The Jefferson

Exhibit B- Updated Site Plan and UDPRP Summary

UDPRP Review Summary

Urban Design Peer Review Panel

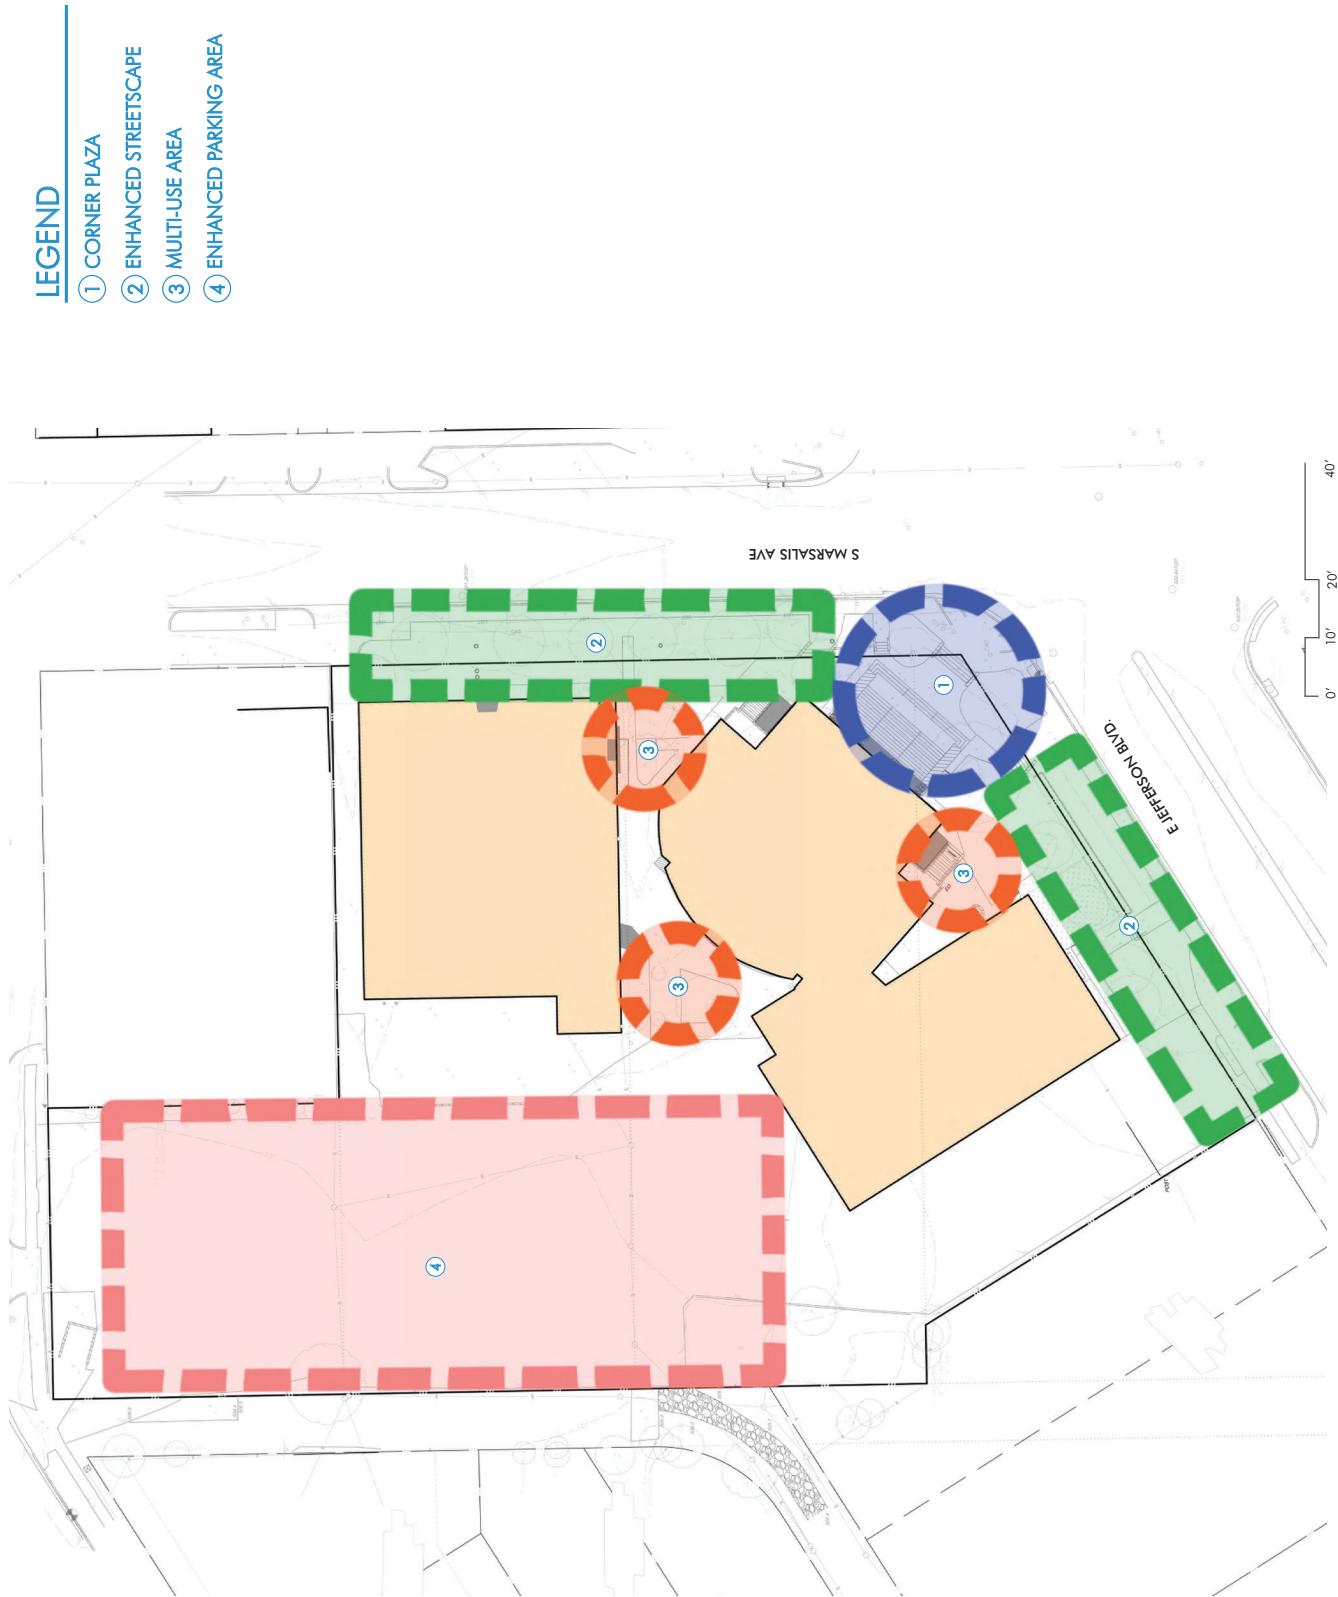
[3] The Panel advises reviewing the site plan for fire access and turning radii. Consider revising parking stall dimensions if necessary.

[4] The Panel recommends considering a more efficient location for the dumpster (possibly in original location) that could also free up additional parking or landscaping.

City Response (11.3.25) – The sidewalk width callout along Marsalis is 5'1", E Jefferson is 5'2" and along E 10th it is 4'8". The City's TIF District Urban Design Standards state "construct sidewalks with a sufficient width to allow for pedestrian and street activity. Typically, a minimum of seven feet of clear, unobstructed walking area is required in addition to the edge and furnishing zones at the back of the curb. Are there constraints such as mature trees or utilities that limit sidewalk width?

City Response (12.5.25) – Staff recognizes the updated site plan indicating the callout for the replacement of sidewalk along E 10th Street and the note regarding lighting installation on private

Applicant Response (10.28.25) - The site plan has been updated to incorporate and identify the fire lane. The fire lane size and turning radii meet the City of Dallas requirements.

Applicant Response (10.28.25) - The site plan has been updated to relocate the new dumpster enclosure to the rear of the site, near the existing location. Parking spaces have been shifted into the previously proposed dumpster location and new landscaping will be provided.

City Response (10.31.25) – Staff agrees the updated dumpster location is more suitably located. With this update, you have met the Panel's recommendation.

Applicant Response (11.18.25) - We have chosen not to modify the existing sidewalk along Marsalis due to the existing row of trees planted very close to the sidewalk. Please see attached letter from the project's landscape architect, Matthew Stubbs, regarding his analysis of the feasibility of expanding this sidewalk without damaging those trees.

property. Staff recognizes that the sidewalk/ADA ramps along Jefferson and Marsalis are new, and tree preservation is desirable. With this update, you have met the Panel recommendation.
